Request	DTC Modification & Overall Height Modification
Project Name	Circle South
Council District	19 – O’Connell
Requested by	D. Tyler Jones, with Circle South Holdings (TN), LLC
Staff Reviewer	Hammer
Staff Recommendation	<i>Approve with conditions and defer without all conditions</i>

A request for A.) Approval for modifying the step-back, and maximum floor-to-floor maximum height standard of the DTC B.) Recommendation for overall height modification to the Planning Commission for property located at 700, 711 and 712 Lea Avenue and 410, 500 and 512 8th Avenue South (1.92 acres), at the intersection of Lafayette Street and 8th Avenue South, and within the Lafayette subdistrict of the DTC.

Downtown Code DRC Meeting of 6/4/2020

Figure 1: Korean Veterans Roundabout Elevation

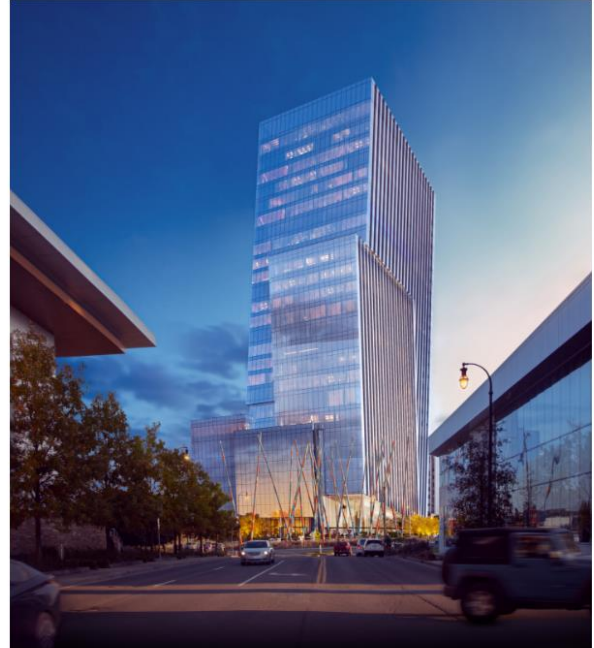
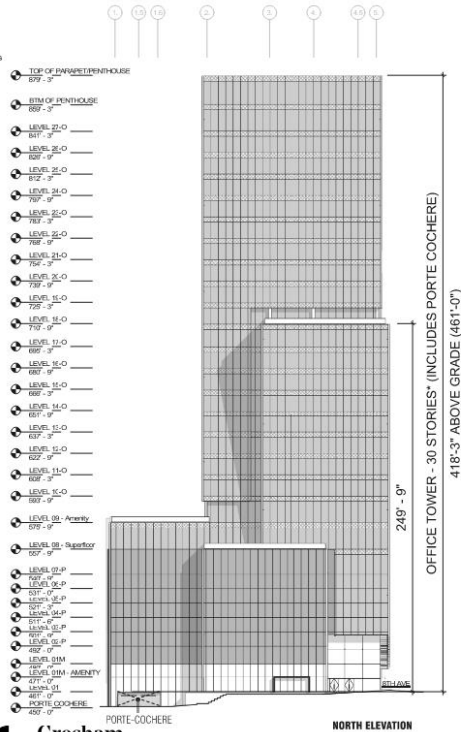
The DTC requires buildings greater than 7 stories to have a 15-foot step-back occur at some point between the 4th and 7th story. This project proposes a massing that leans away from the roundabout, but does not constitute a full-step-back as required. The intent of a step-back is to allow light and air to reach the street for the benefit of pedestrians and to avoid a canyon effect. Step-backs are most important for narrow streets, as increased proximity of buildings on the other side of the right-of-way has a greater potential to create a canyon effect.

However, diameter of both adjacent rights-of-way and the roundabout are very wide compared to most other streets within this subdistrict. In addition, the building is buffered from the right of way by pedestrian amenities and open space, allowing for more light and air to reach the street level.
